SUBJECT: ISSUANCE OF AMENDMENTS FOR DIABLO CANYON NUCLEAR POWER PLANT, UNIT
NOS. 1 AND 2 (TAC NOS. M80633 AND M80634)

These amendments revise the combined technical specifications (TS) for the Diablo Canyon Nuclear Power Plant Unit Nos. 1 and 2 to relocate cycle-specific information to the Core Operating Limits Report (COLR) in accordance with Generic Letter (GL) 88-16.

ATTACHMENT TO LICENSE AMENDMENT NOS. 71 AND 70

SAFETY EVALUATION BY THE OFFICE OF NUCLEAR REACTOR REGULATION
RELATED TO AMENDMENT NO. 71 TO FACILITY OPERATING LICENSE NO. DPR-80
AND AMENDMENT NO. 70 TO FACILITY OPERATING LICENSE NO. DPR-82
PACIFIC GAS AND ELECTRIC COMPANY
DIABLO CANYON NUCLEAR POWER PLANT, UNIT NOS. 1 AND 2
DOCKET NOS. 50-275 AND 50-323

FIGURE 3.2-3a

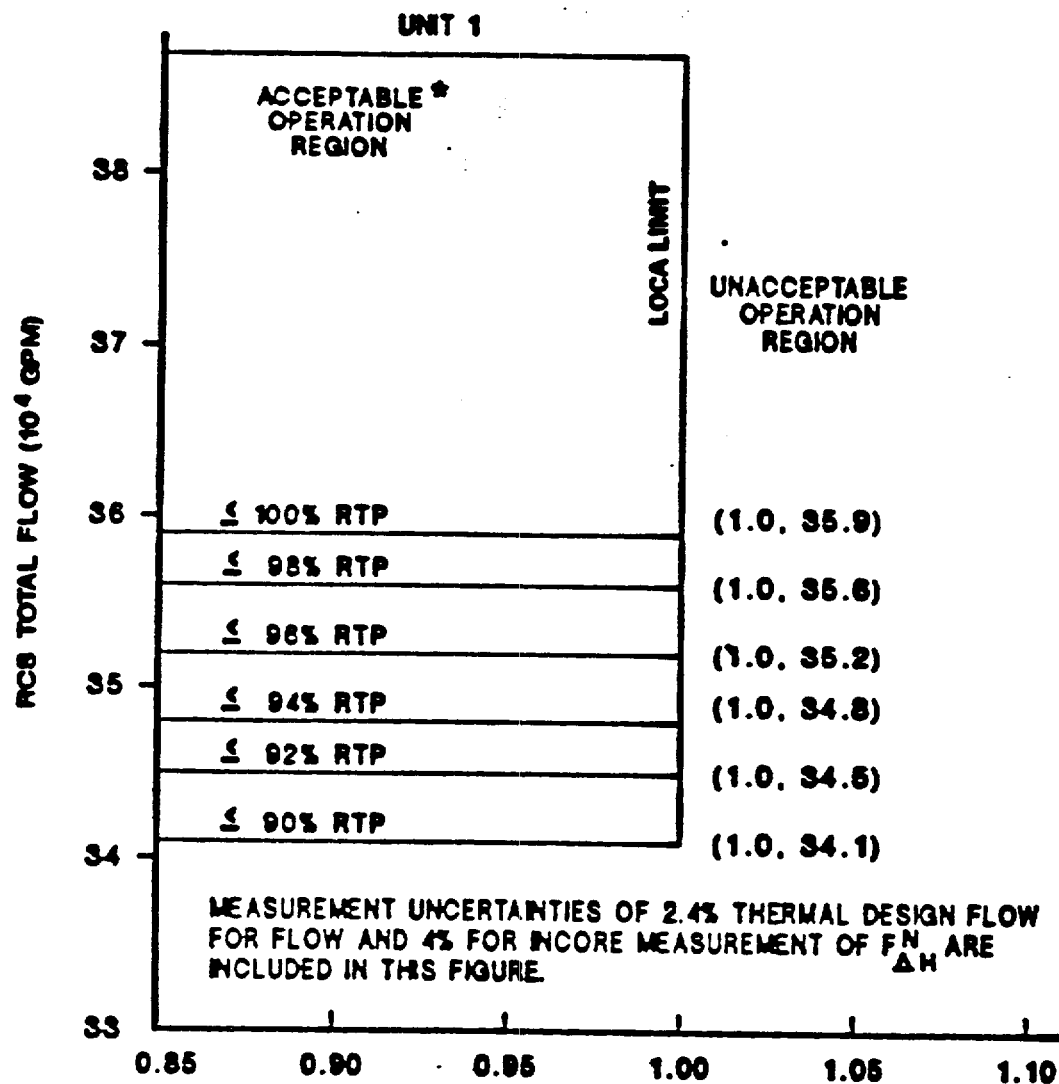
3. TS 3/4.2.3, "RCS Flow Rate and Nuclear Enthalpy Rise Hot Channel Factor," has been changed to relocate $F^n \Delta H$ to the COLR. The numerical values for the $F^n \Delta H$ limit and part power multiplier have been replaced by the parameter $F^{RTP} \Delta H$ and Power Factor ΔH (PF ΔH), which are defined in the COLR. TS Figures 3.2-3a and 3.2-3b have been revised to be consistent with TS 3/4.2.3.

$$R = \frac{F_{\Delta H}^N}{F_{\Delta H}^{\text{RTP}} \text{ LOPAR FUEL}} (1.0 + PF_{\Delta H} (1.0 - P))$$

$$R = \frac{F_{\Delta H}^N}{F_{\Delta H}^{\text{RTP}} \text{ VANTAGE 5 FUEL}} (1.0 + PF_{\Delta H} (1.0 - P))$$

*WHEN OPERATING IN THE RESTRICTED POWER
REGION, THE RESTRICTED POWER LEVEL SHALL
BE CONSIDERED 100% RTP FOR FIGURE 2.1-1
